Addendum No. 1
TERMINAL TANK PH IMPROVEMENTS
PWP Bid No.: WA-2017-029
TMWA Capital Project No.: 11-0014
December 5, 2016

QUESTION AND RESPONSE

DRAWINGS

TERMINAL TANK MECHANICAL SITE PLAN

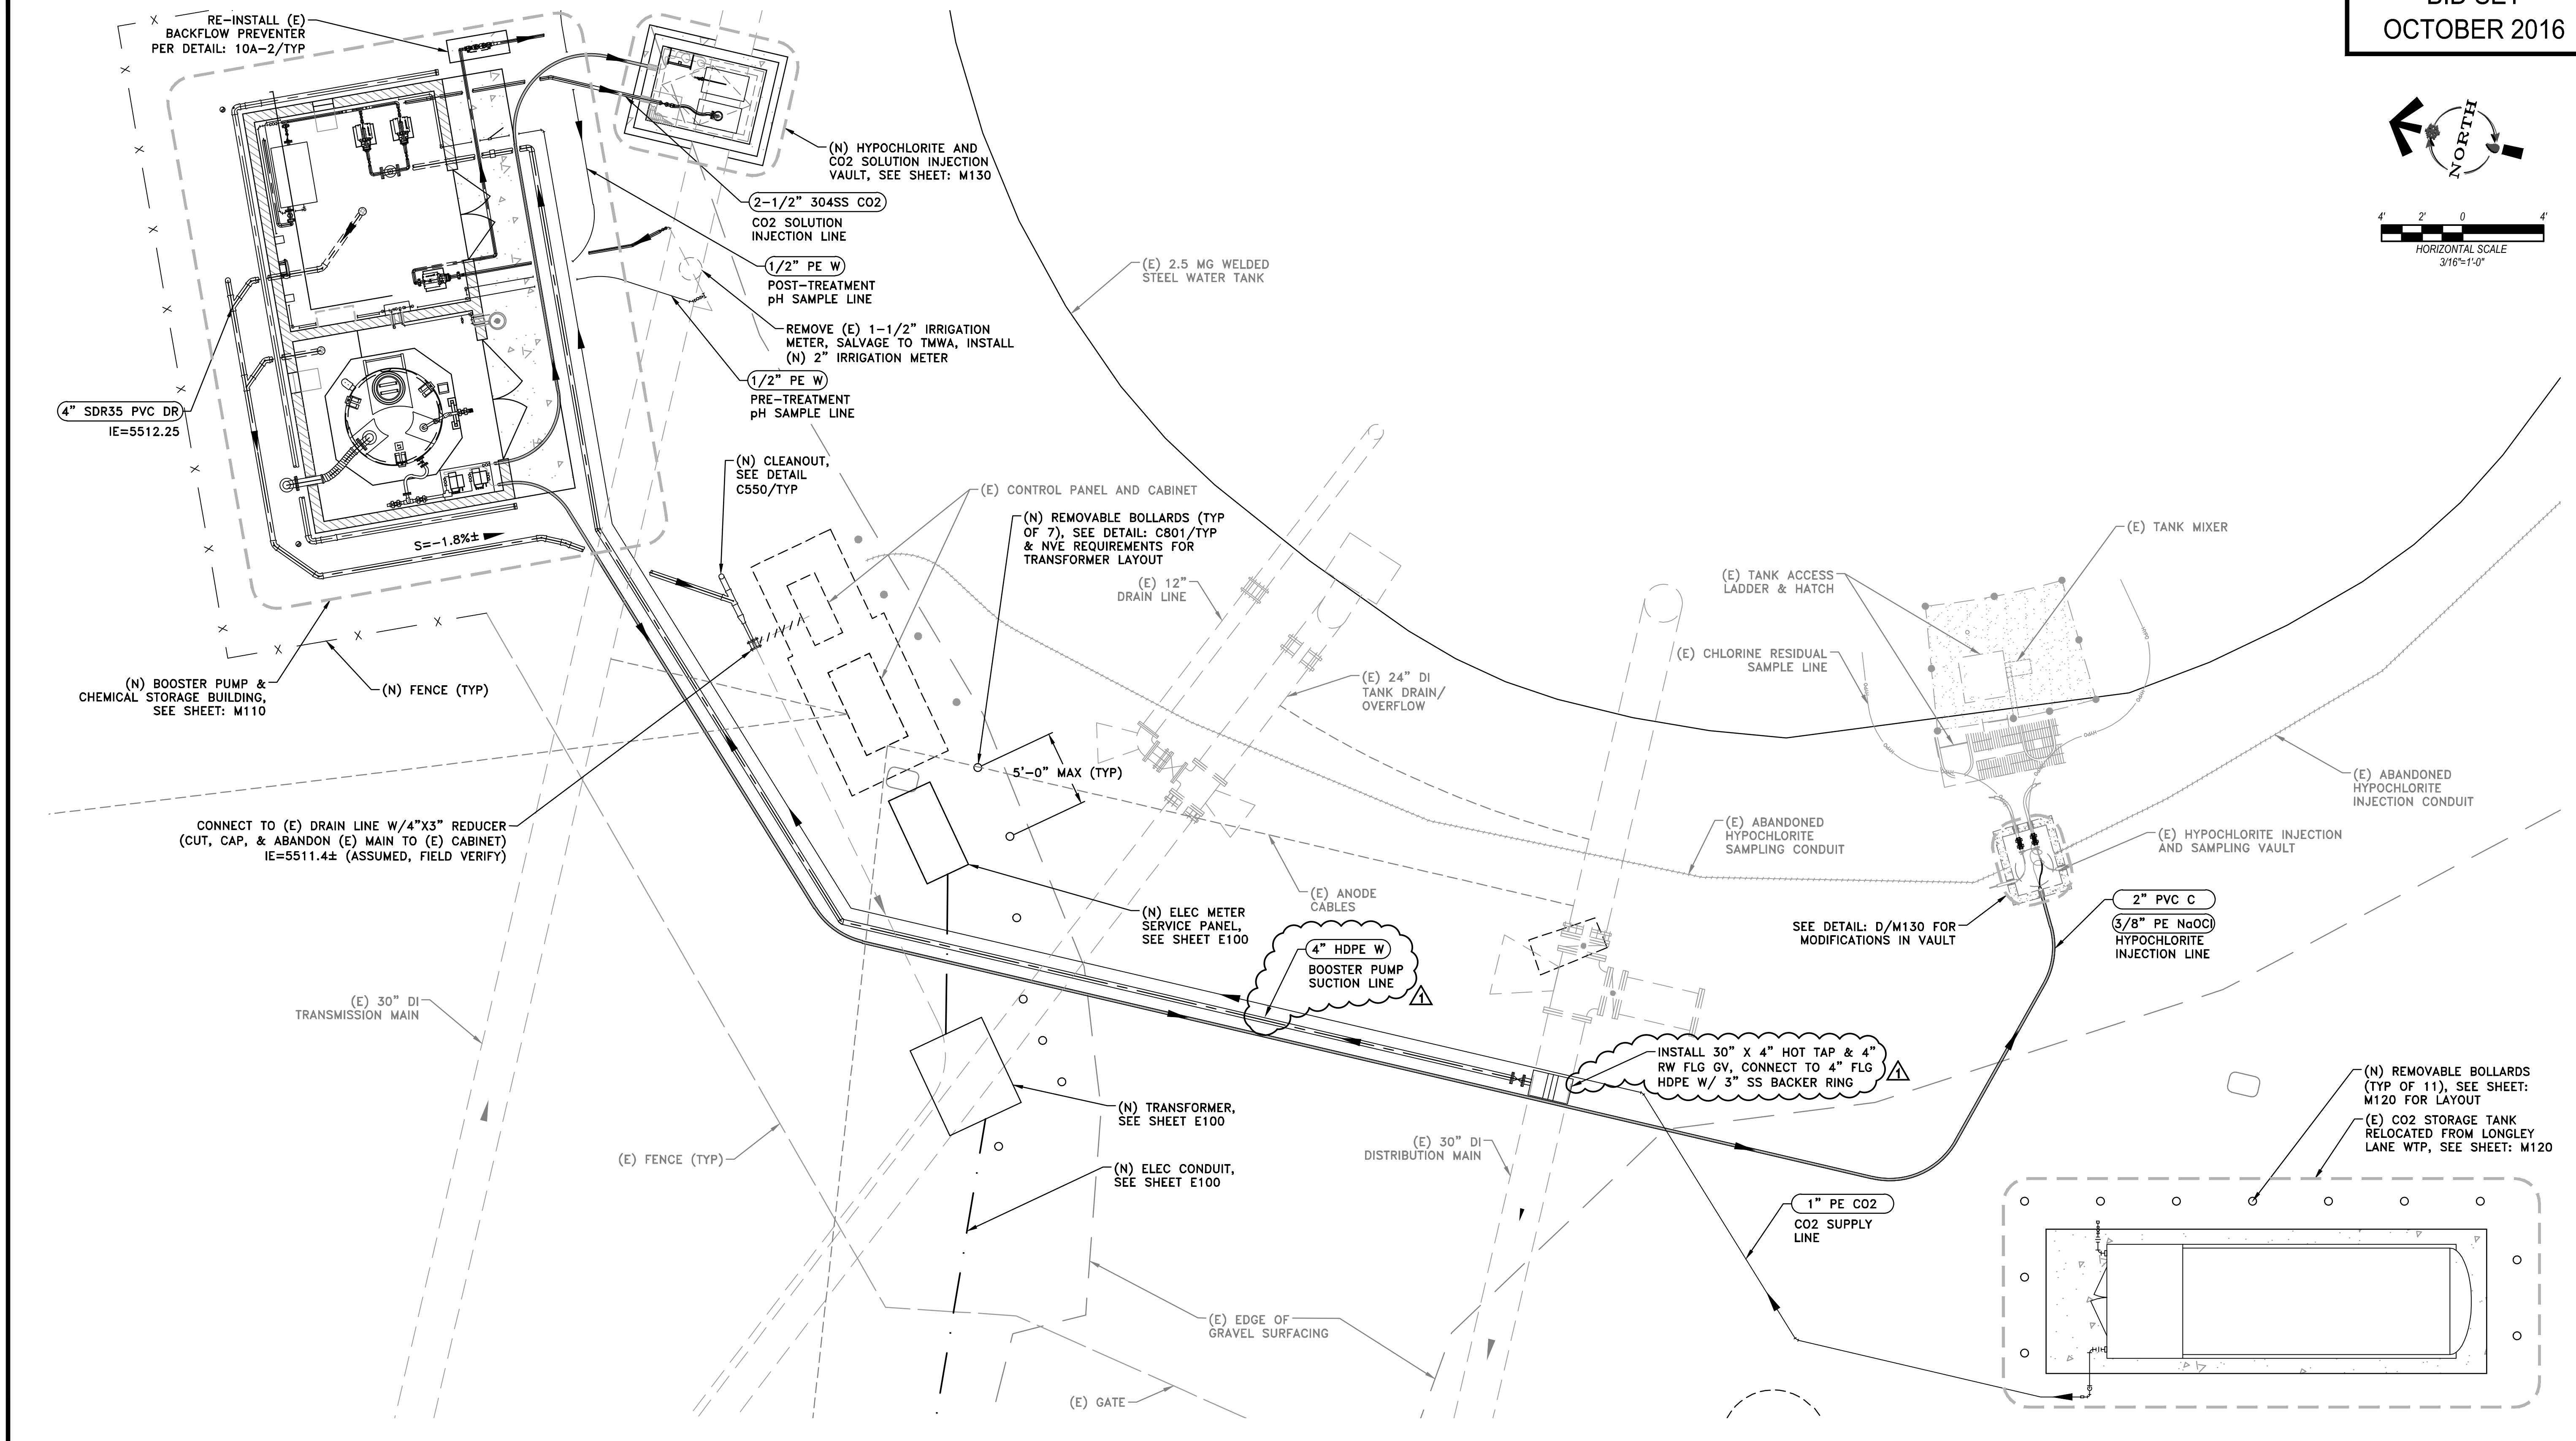
Sheet Number	Description of amendment
M100	The booster pump suction line diameter was increased from 3 inches to 4 inches. Please see attached drawing for changes.
M110	The booster pump suction line diameter was increased from 3 inches to 4 inches, and the booster pump suction was reconfigured. A 2" check valve was added to the CO2 unit suction line. A portion of the lines material was changed from galvanized steel to fusion epoxy lined and coated steel. Please see attached drawing for changes.
M111	Added a 2" Check valve to the suction side of the CO2 feed panel.
M112	The booster pump suction line diameter was increased from 3 inches to 4 inches, and the booster pump suction was reconfigured. Please see attached drawing for changes.
E001	The power wire size and ground wire size to UH-1 and UH-2 was changed from #12 to #10 wires. See attached drawing E001
E002	The circuit breakers to UH-1 and UH-2 were changed from 20A breakers to 30A breakers. Power supply was changed from 3 phase to single phase. See attached drawing E002

BOOSTER PUMP & CHEMICAL STORAGE BUILDING MECHANICAL PLAN

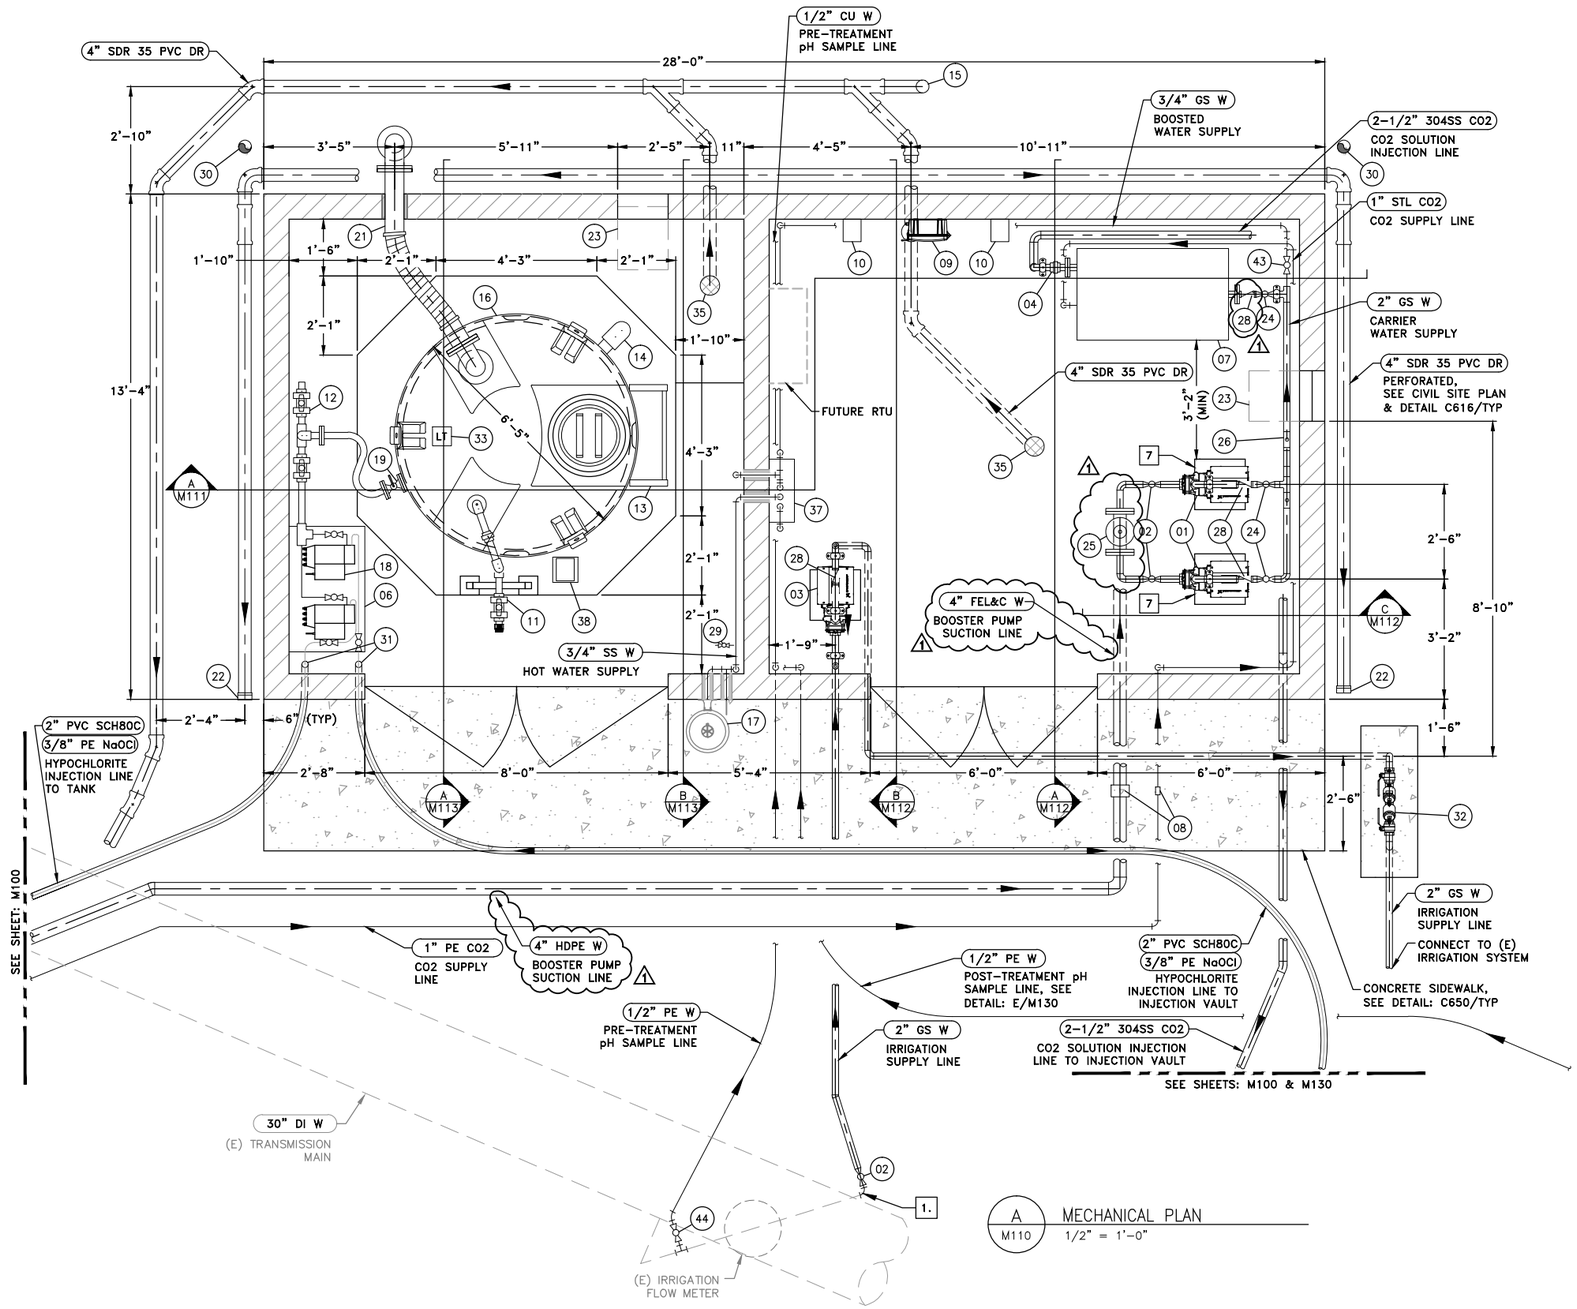
Question No. 8 On Sht. M110 equipment list, item 6 references a meter pump stand and detail M711. Item 18 references detail M710. The pumps are listed as owner furnished. In the pump specification 11240 2.1B it states the each pump be supplied with PRV, calibration column and be pre-plumbed on existing chemical stand. Please clarify if new stand is required to be supplied by contractor. Also, please clarify which appurtenances are required in detail M710.

Response to Question No. 8: The FRP utility stand shown in detail M711 is to be provided by the contractor. All piping shown in detail M710 should be assumed to be provided by the contractor.

ONE LINE DIAGRAM

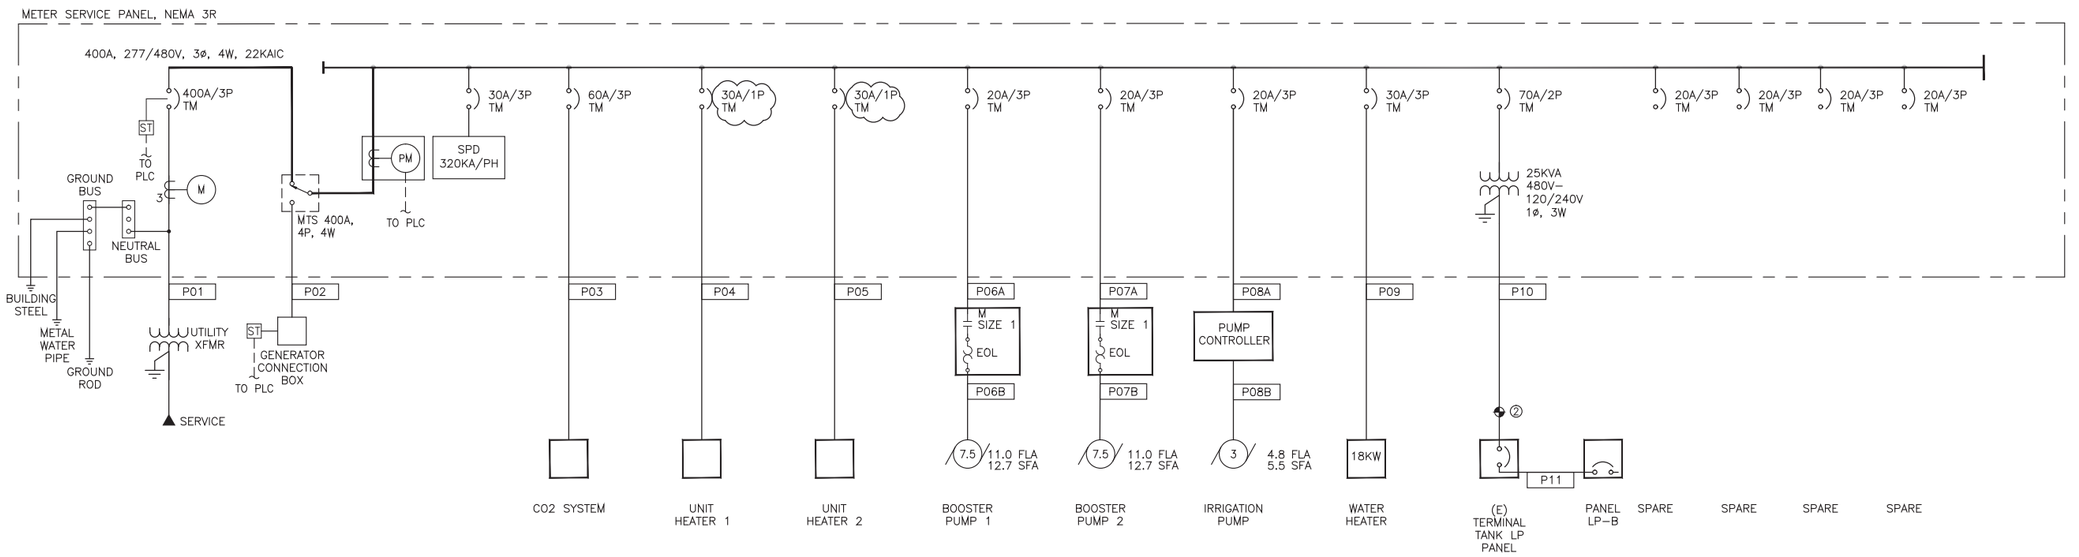
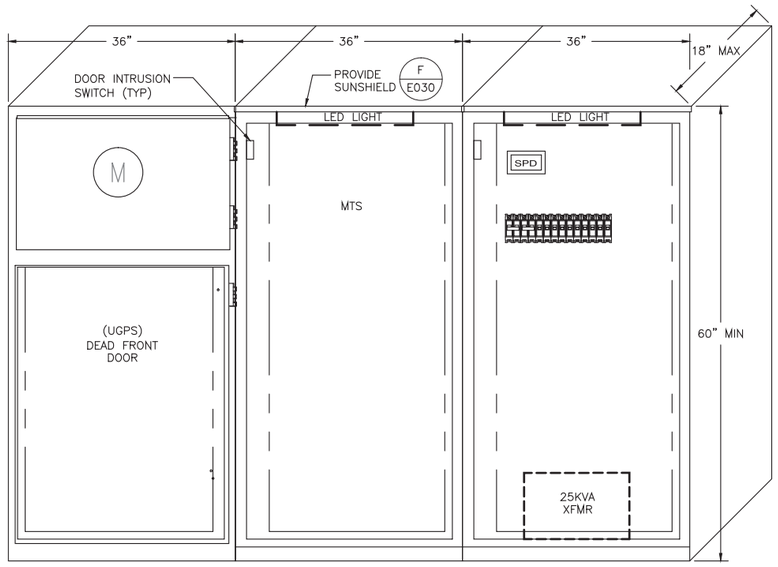
Question No. 7: I have a question as to who is providing the pump controller (irrigation pump 3hp) as shown on drawing E002. If that is in the electrical scope of work, what functionality and product is required? Part number or diagram?

Response to Question No. 7: Relocate the existing pump controller shown in drawing D101 as "Remove and Salvage" to within the new building.
